Team Tips

ARTICLE: I-16-03-01

SUBJECT: Indian Full-Size Motorcycles – Fuel Pump Service Information

UPDATED FUEL PUMP (2521632)

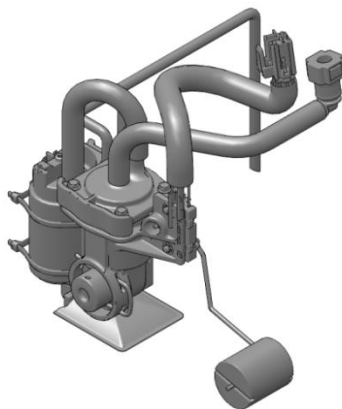
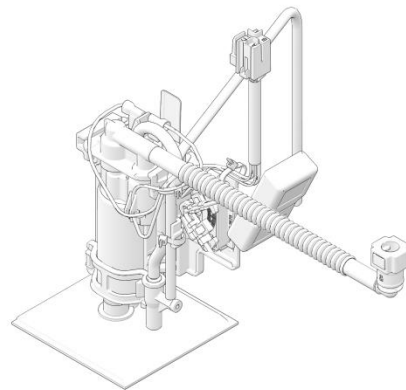
Indian Motorcycle has implemented an updated, maintenance-free fuel pump assembly for all full size Indian motorcycles produced from November 11, 2015. The updated fuel pump is a direct replacement for the previous version and does not affect fuel pump removal or installation procedures.

- The updated fuel pump assembly (PN:2521632) has a white pump housing. The previous fuel pump assembly (PN:2521305) has a black pump housing.
- The updated fuel pump assembly does not have a replaceable filter element and does not require routine maintenance. The service life of the updated fuel pump is intended to exceed that of the previous pump. Refer to Service Manual for fuel pump replacement and specifications.
- Replacement fuel filters for fuel pump (2521305) will remain available for purchase through normal channels.
- Orders placed for fuel pump PN:2521305 will supersede to PN:2521632.

-Extended life, maintenance-free pump
